# AERONAUTICAL CHARTING MEETING

## Instrument Procedures Group

### RECOMMENDATION DOCUMENT

**Subject:** Intermediate Segment Stepdown Altitudes

compliance with the intermediate segment stepdown fix altitudes on these approaches is similar to an ILS glideslope, as illustrated by this example - KDFW RNAV(GPS) Rwy 17C:

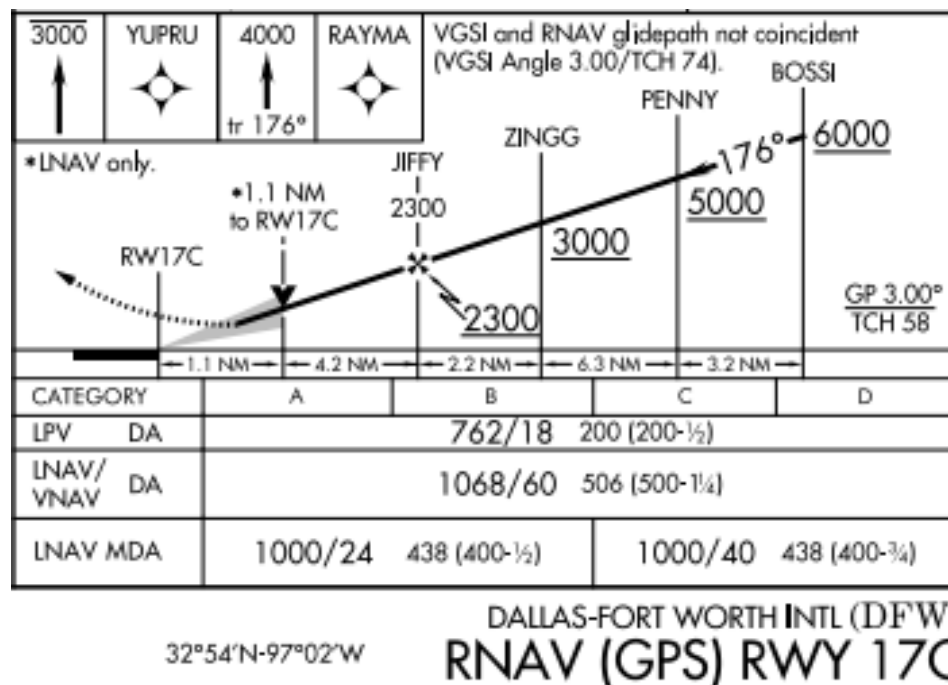
NBAA has recently learned that certain WAAS-SBAS capable RNAV systems will begin using WAAS-SBAS vertical guidance starting at the Final Approach Course Fix (FACF), which is typically, but not always co-located with the intermediate fix (IF) on an RNAV approach. Since the WAAS-SBAS generated vertical path is not subject to hot/cold temperature effects as occurs with a barometric derived (Baro-VNAV) vertical path, the effects of hot temperatures on

- At 100°F, ZINGG is 200' above the WAAS-SBAS glidepath
- At 130°F (charted limit), ZINGG is 300' above WAAS-SBAS glidepath

An aircraft descending using VNAV, which is generated by WAAS/SBAS and not Baro-VNAV, and on the vertical path would cross below the published altitudes at PENNY, ZINGG and JIFFY if BOSSI is designated at the FAF in nav-database coding.

NBAA recommends that the policy memorandum be incorporated into JO 8260.3 U.S. TERPS and on approaches where LPV minima are published, in FAA Order 8260.58.
